Interested Party: [REDACTED] (David Burns)

In their new document pack National Grid have provided figure A13.5.3 which illustrates the 'Reverse Zone of Theoretical Visibility'.

Zone of Theoretical Visibility (ZTV) - Dedham Vale National Landscape

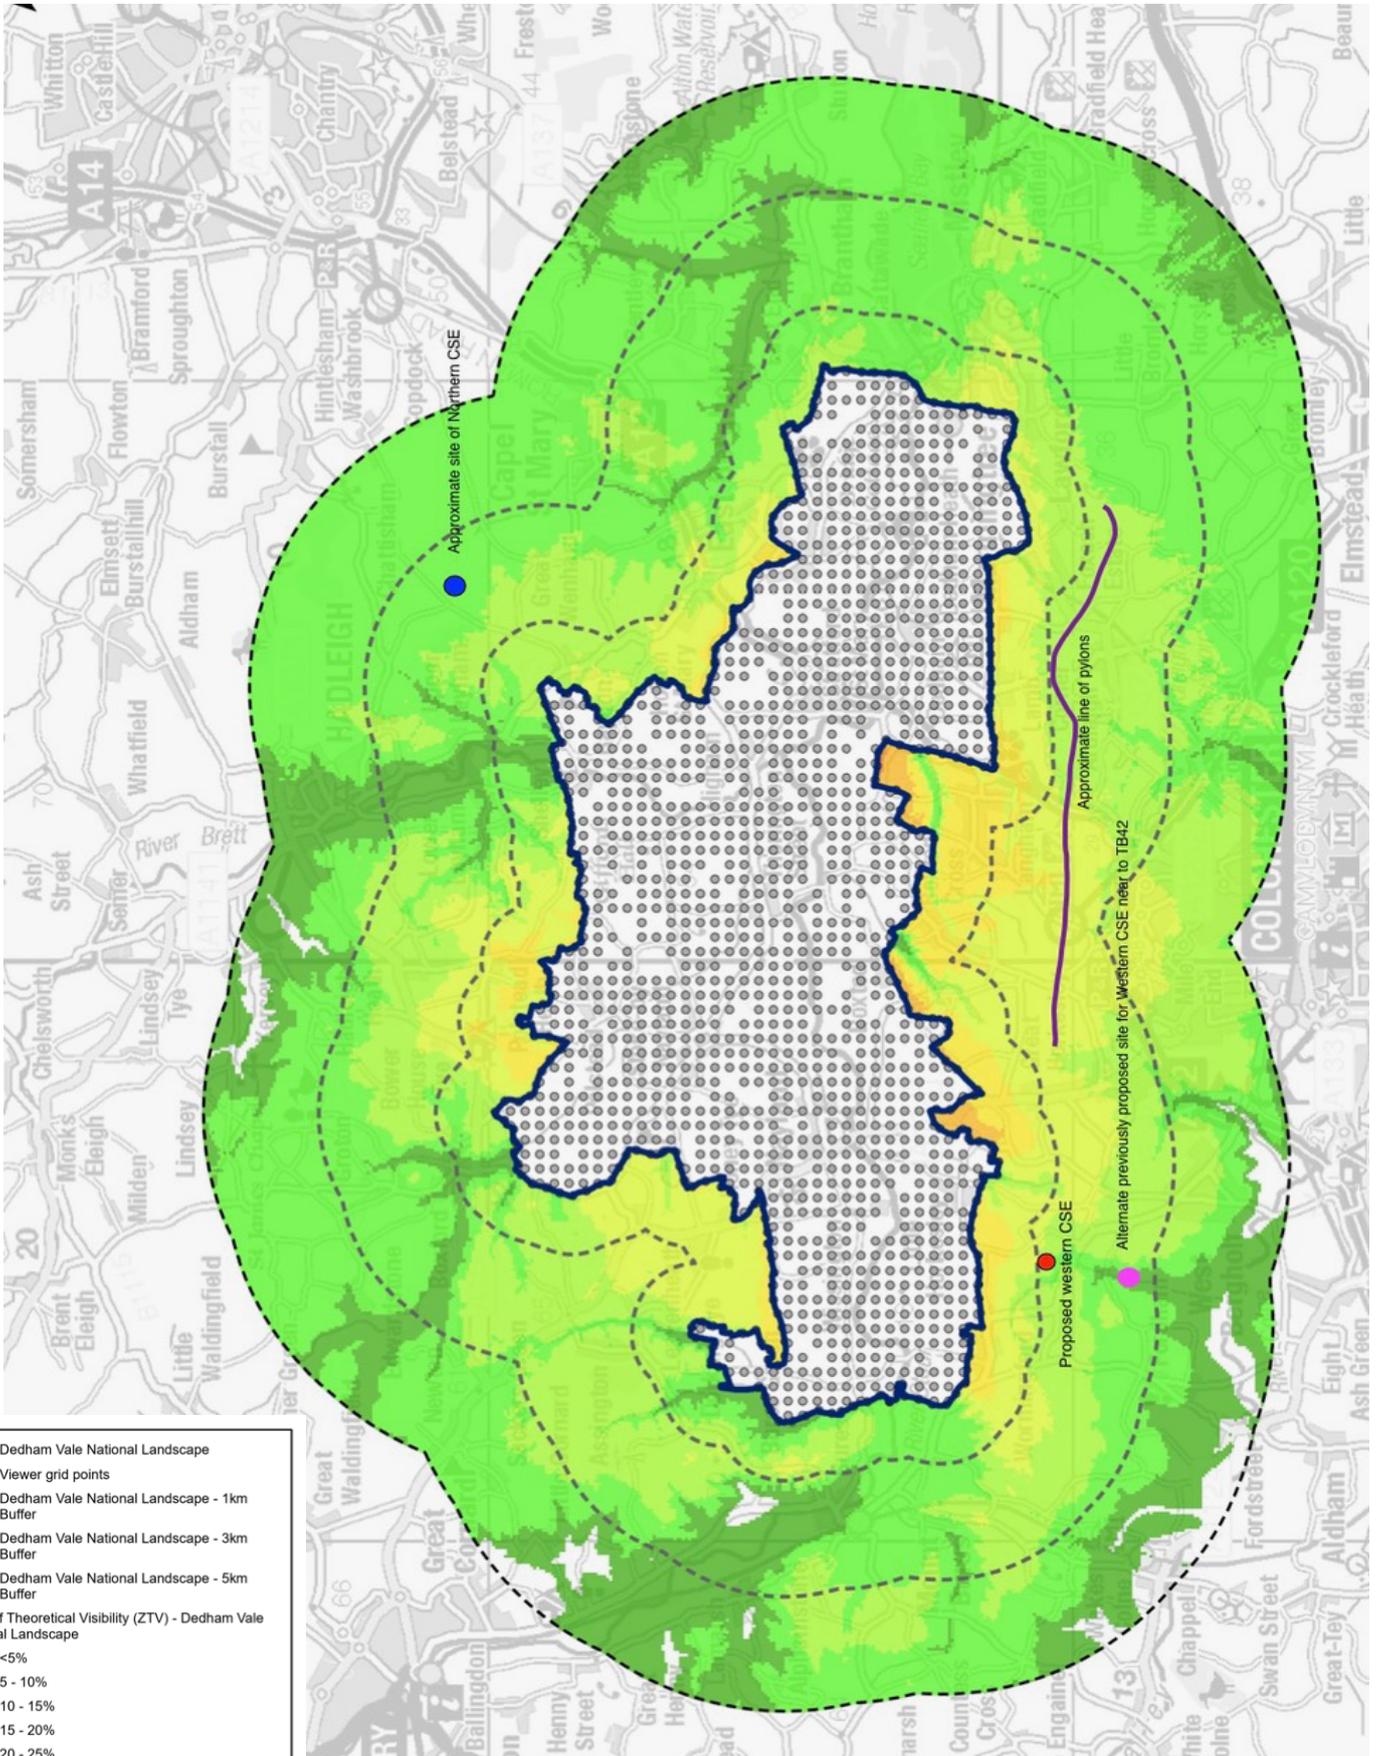
This diagram very much reinforces our point but is barely mentioned in the text: the route selected for pylons emergent from Ardleigh and the location of the Western CSE in particular are extremely poor. The EACN is in a location where it will be visible over between 20% and 25% of the Dedham Vale, as are many of the pylons. All fall within the 10-15% category.

It must be remembered that these are **individual** point wise measurements, being a reverse view fall map and that, as a result, the full impact arising within the Vale from the presence of all of the pylons in the South will be **dramatically higher** than suggested.

Had the Western CSE at Little Horkesley (red circle in lower left of diagram) been moved only 500m (per National Grid, the additional underground distance is less than the absolute distance between the two sites as the underground route going in would be altered slightly) to the south near to their alternatively proposed site near to TB42 (pink circle at bottom of diagram) it would have fallen into a valley from which it would have been visible over less than 5% of the Dedham Vale and from which it would not have interrupted any views from **any** historic buildings into the Vale. Subsequent pylons would also have similarly far less visible.

Interestingly, to the North of the Dedham Vale the site of the relevant Sealing End Compound there has been moved by National Grid even further North on the argument that visibility within the Vale needed to be reduced (Blue circle at top of diagram). The original choice of site was already **far less impactful** on the Dedham Vale than the one they are now defending at TB35/36 in Little Horkesley and they have reached the conclusion that it needed to be further away.

The planning inspectorate MUST require AT THE VERY LEAST a change from TB35/36 to TB42 or beyond.
